Cabarrus County Planning and Zoning Commission Meeting
July 19, 2007
7:00 P.M.
County Commissioners Chamber
Multi-Purpose Room, 2nd Floor

PLANNING STAFF REPORT
CABARRUS COUNTY PLANNING AND ZONING COMMISSION
Thursday, July 19th, 2007

Petition: C2007-05 (S) Preliminary Plat Approval

Subdivision Name: Rocky Glen

RESIDENTIAL COLLECTOR (PARKWAY)

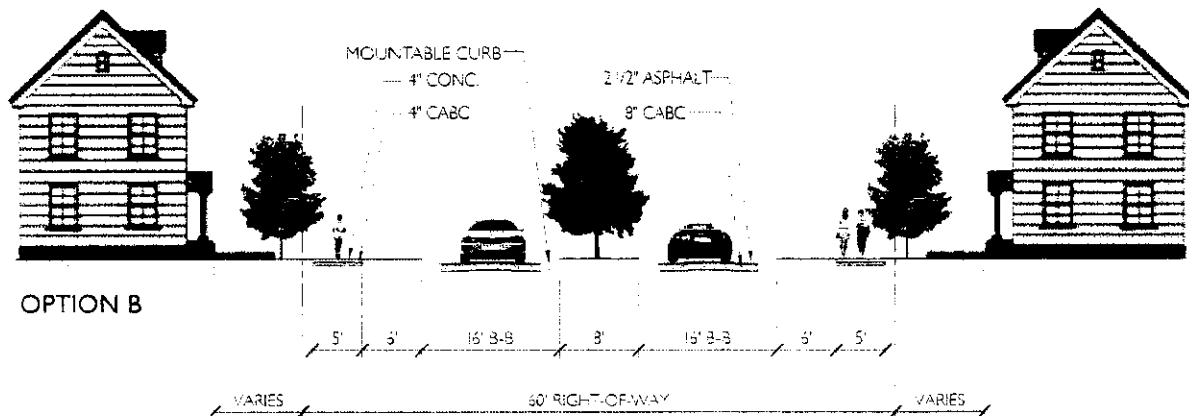
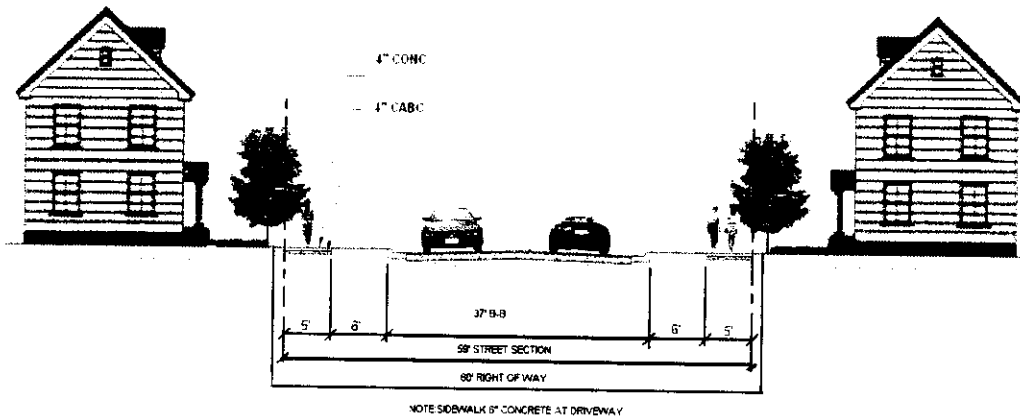
To: Cabarrus County Board of Commissioners
From: Susie Zakraisek, AICP, Planning and Zoning Manager
CC: File
Date: July 10, 2007
Re: Subdivision Ordinance Text Amendment C2007-01-ST -Appendix A, Typical Street Standards

Attached you will find proposed changes to the typical street standards in Appendix A of the Cabarrus County Subdivision Ordinance.

These proposed changes relate to the administration of the street standards that were adopted as part of the ordinance update that occurred in June of 2005. The standards that were adopted are not consistent with the standards that the NCDOT uses. Streets must comply with the established NCDOT standards for the streets to be accepted by the NCDOT for maintenance and repair.

Right-of-Way	Sidewalks	Planting Strips	Street Width	Median	Parking	Design Speed	Curb Type
70'	5'	6'	2 x 16'	16'	None	40 mph	30" Standard

- NO DIRECT LOT ACCESS ALONG RESIDENTIAL COLLECTOR (PARKWAY)
- THE MEDIANS OF THE PARKWAY SHALL TERMINATE 100' EACH WAY FROM THE CENTERLINE OF ALL INTERSECTIONS
